KEYSTONE XL PIPELINE PROJECT

0385-SD-P4-439.9-440.2-1

Proposed Route Variation 0385-01

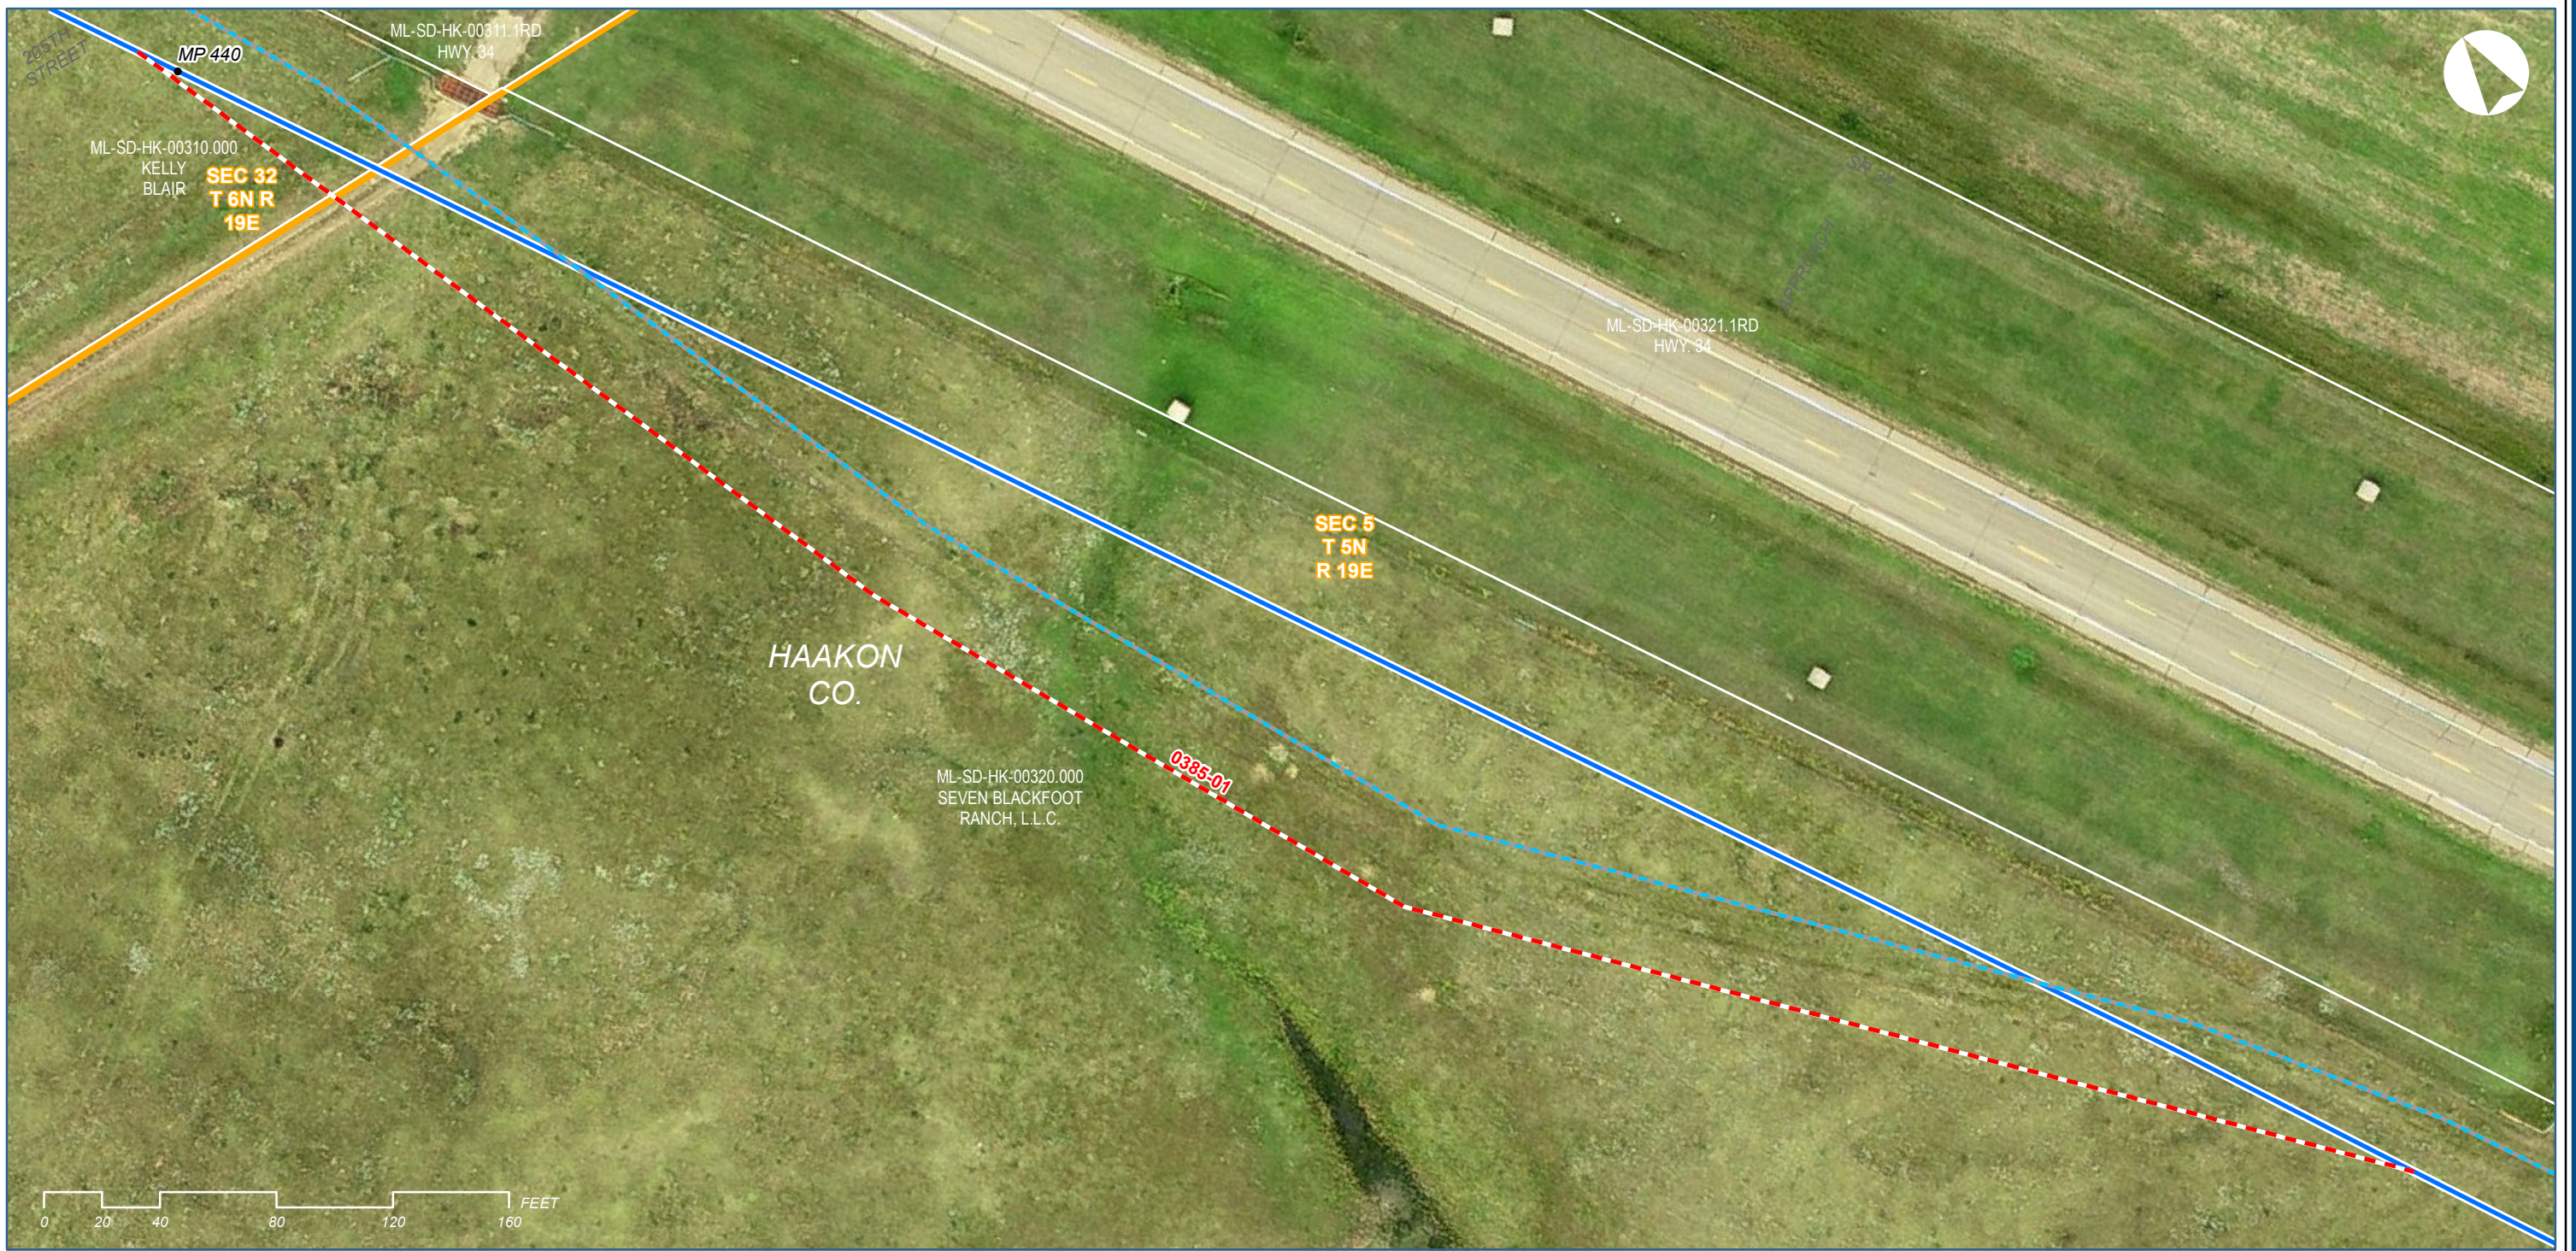
3	REASON FOR ROUTE VARIATION (Please include reason for route variation):		
	<p>The primary reason for this route variation is to avoid crossing the West River Lyman Jones Waterline (WAT-14650 &-14651, 3 diameter) multiple times. Additionally, this proposed reroute improves the crossing angle of 205th st from 59° to 69°.</p> <p>This proposed reroute is requested by Engineering and is proposed based on the recommendations from the CPMS 60% Design Review. The proposed reroute was drawn based on a combination of aerial imagery, Pictometry, and LIDAR data.</p>		
	DETAIL ROUTE VARIATION (Please describe route variation in detail):		
	<p>The proposed route variation starts near MP 440.0 and deviates ~10.5° southwest of the current centerline. It extends in this direction for ~315 ft. The reroute then turns slightly east and continues for ~210 ft. The proposed route variation, makes a final turn east towards the current CL, where it extends for ~ 359 ft. to rejoin the current CL near MP 440.2.</p>

ADDITIONAL IMPACTS (Please include any additional impacts which may affect cost; crossings, induction bends, etc.):		
	<p>2 Tracts are impacted by this centerline reroute: ML-SD-HK-00310.000 (Kelly Blair) ML-SD-HK-00320.000 (Seven Blackfoot Ranch, LLC)</p> <p>The proposed route variation falls within the current environmental surveyed corridor, so no additional costs associated with environmental surveys will be incurred. Additionally, it eliminates 2 bore crossings of the WRLJ waterline (~40 ft.) and reduces the bore length at the road crossing.</p>		
	Is there an increase/decrease in the number of crossings?	Yes <input type="text"/>	No <input checked="" type="checkbox"/> X
	If yes, please list: <input type="text"/>		
	COST ANALYSIS (costs incurred or saved from the route variation)		
	Additional length of route realignment:	<input type="text" value="13"/> ft.	\$ <input type="text" value="4,596.85"/> \$ 360/ft

KEYSTONE XL PIPELINE PROJECT ROUTE VARIATION AUTHORIZATION FORM	
Date: 10/29/2012	Tracking Number: 0385-SD-P4-439.9-440.2-1
Description: The primary reason for this route variation is to avoid crossing the West River Lyman Jones Waterline (WAT-14850 6-14851, 3 diameter) multiple times. Additionally, this proposed reroute improves the crossing angle of 205th at from 59° to 69°.	MP: 440.0 to 440.2 Originated By: Engineering
TransCanada - Land Tina Hall	Variation: Approved <input checked="" type="checkbox"/> Rejected <input type="checkbox"/> Date: 11-5-12
Comments:	If Rejected Why?
TransCanada - Engineering Meera Kohari	Variation: Approved <input checked="" type="checkbox"/> Rejected <input type="checkbox"/> Date: 11/2/12
Comments:	If Rejected Why?
Exo - Engineering Kevin McGlynn	Variation: Approved <input checked="" type="checkbox"/> Rejected <input type="checkbox"/> Date: 12/14/12
Comments:	If Rejected Why?

TransCanada - Environmental Sandra Barnett	Variation: Approved <input checked="" type="checkbox"/> Rejected <input type="checkbox"/> Date: 12/14/12
Comments:	If Rejected Why?
Stantec - Risk Assessment Heidi Tillquist	Variation: Approved <input type="checkbox"/> Rejected <input type="checkbox"/> Date:
Comments: N/A	If Rejected Why?
TransCanada - Facilities Sandra Gigovio	Variation: Approved <input type="checkbox"/> Rejected <input type="checkbox"/> Date:
Comments: N/A. Does not affect facilities	If Rejected Why?
TransCanada - PM (Montana) Alan Lietz	Variation: Approved <input type="checkbox"/> Rejected <input type="checkbox"/> Date:
Comments:	If Rejected Why?
TransCanada - PM (South Dakota) James Odom	Variation: Approved <input checked="" type="checkbox"/> Rejected <input type="checkbox"/> Date: 12/10/12
Comments:	If Rejected Why?
TransCanada - PM (Nebraska) Robert Bradley	Variation: Approved <input type="checkbox"/> Rejected <input type="checkbox"/> Date:
